Department of Energy

VARIANCE TO REVISION 0 OF THE WASTE PITS REMEDIAL ACTION PROJECT WASTE PIT 4 CAP EXCAVATION IMPLEMENTATION PLAN

VARIANCE / FIELD CHANGE NOTICE	V/F 10000-PL-0001-1
WBS NO.: 14000-PL-0001 Rev. 0	Page 1 of 1
PROJECT TITLE: Waste Pit Remedial Action Project Waste Pit 4 Cap Excavation Implementation Plan	Date 8/28/02

FIGURE 4-3. PIT 4 CAP TOTAL URANIUM RESULTS (IN PARTS PER MILLION) AND TECHNETIUM-99 RESULTS (IN pCi/g)
(REV 1)

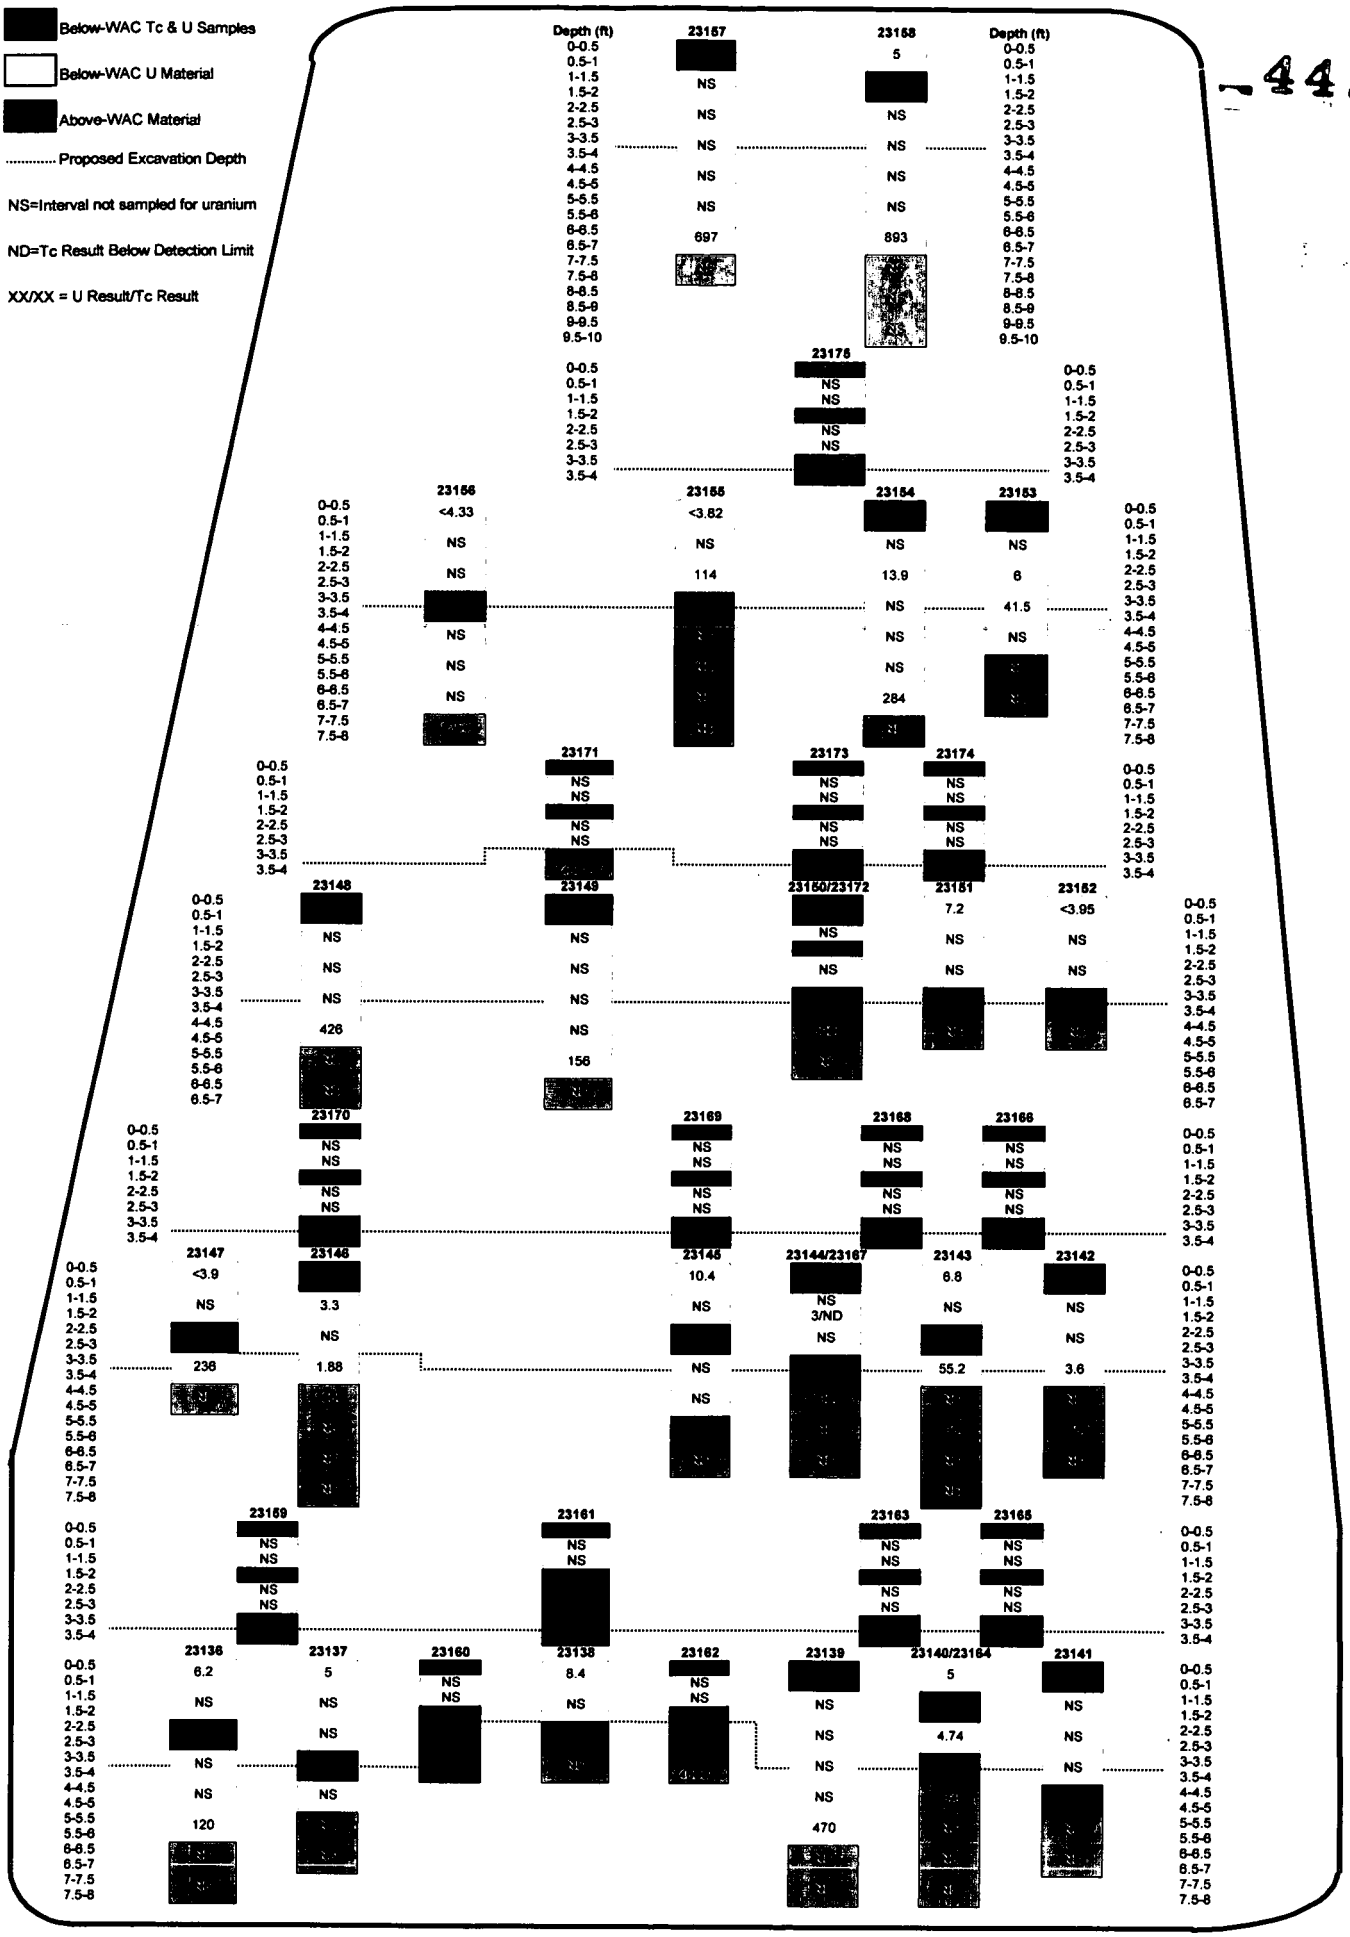
- Adding all technetium-99 results to the total uranium results displayed on Figure 4-3 for all thirty Pit 4 cap characterization borings
- Extension of the eastern boundary of the southern <3.5 feet excavation zone to extend the zone 15 feet beyond Boring 23162
- Reduction of the excavation depth of the southern <3.5 feet excavation zone from 2.5 feet to 2.0 feet
- Creation of a central <3.5 feet excavation zone centered around Boring 23146 with an excavation depth of 3.0 feet
- Creation of a northern <3.5 feet excavation zone centered around Boring 23171with an excavation depth of 3.0 feet

1.) Replace Figure 4-3 with the attached Revision 1 of Figure 4-3
2.) Replace Figure 5-2 with the attached Revision 1 of Figure 5-2
3.) Add the attached list of 18 technetium-99 results to Appendix A
